From: Mess, Camie
Sent: Thursday, January 17, 2019 10:15 AM
To: 'bwardell@brw-architects.com'
Cc: Werner, Jeffrey B
Subject: January BAR Action - 301 East Jefferson Street

BAR 19-01-01
301 East Jefferson Street
Tax Parcel 330204000
Diane Hillman, Owner/Bruce Wardell (BRW Architects), Applicant
New Site Modifications (fence, benches, and upgraded lighting)

**CITY OF CHARLOTTESVILLE
BOARD OF ARCHITECTURAL REVIEW
STAFF REPORT
January 15, 2019**

SECURITY UPGRADES

1 DETAIL - BENCH
Scale: 1 1/2" = 1'-0"

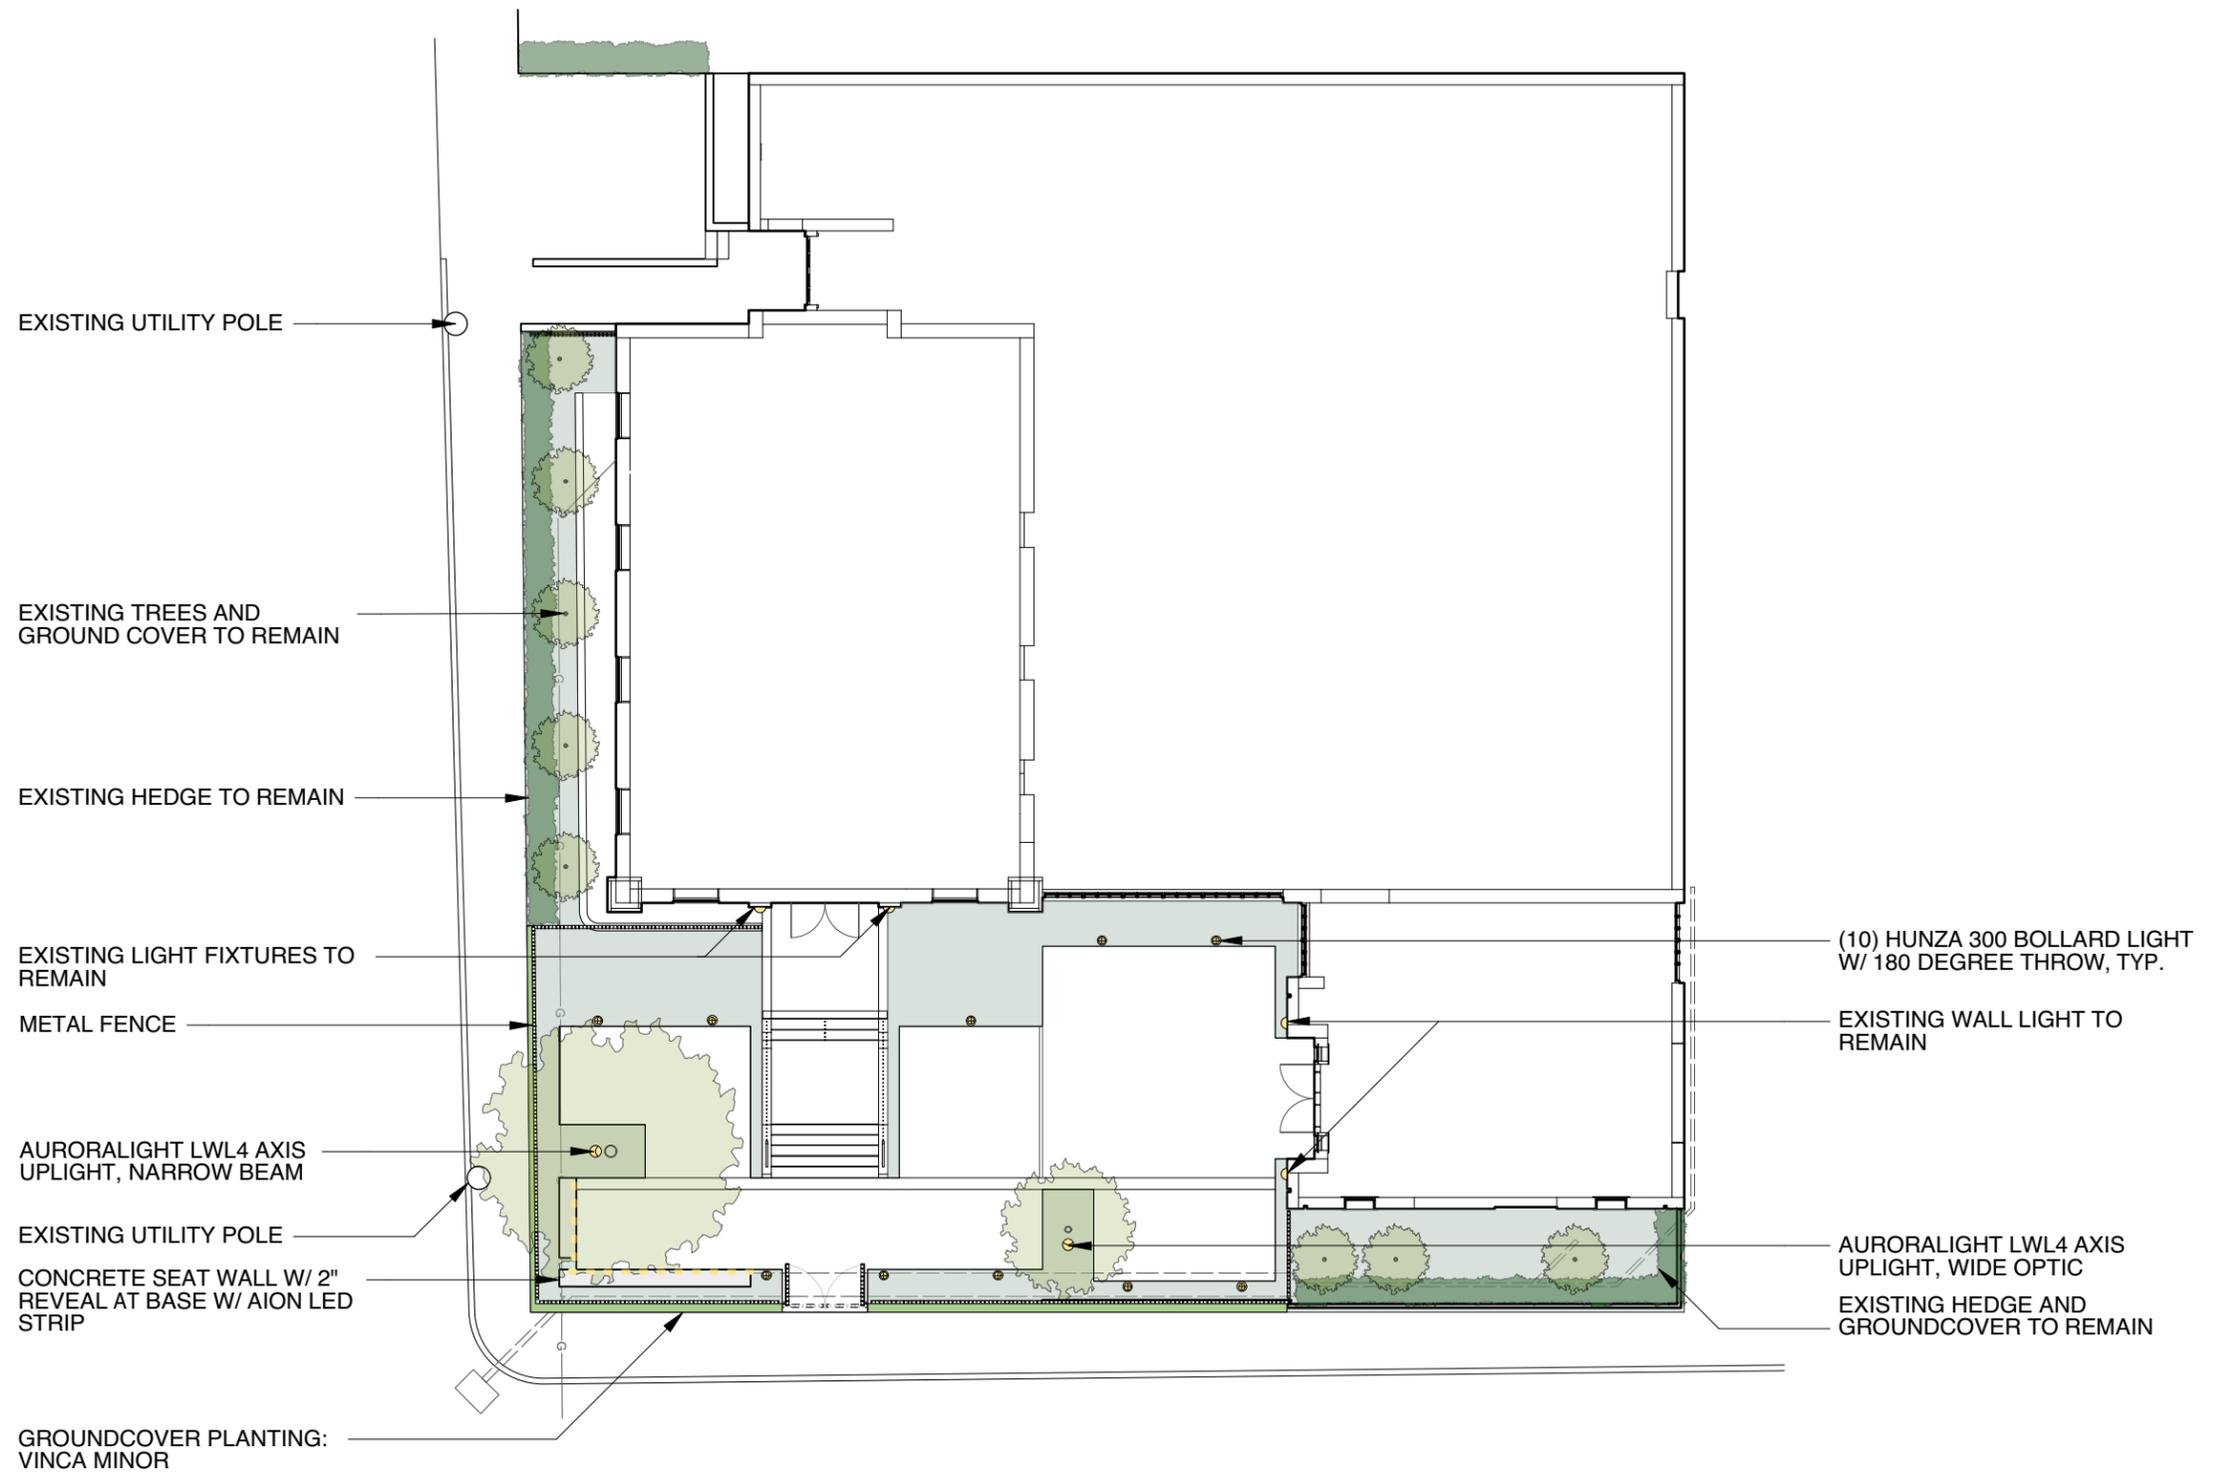
- adding additional low plantings around the perimeter fence
- making sure the new concrete benches are compatible with the existing concrete [in the courtyard and stairs]
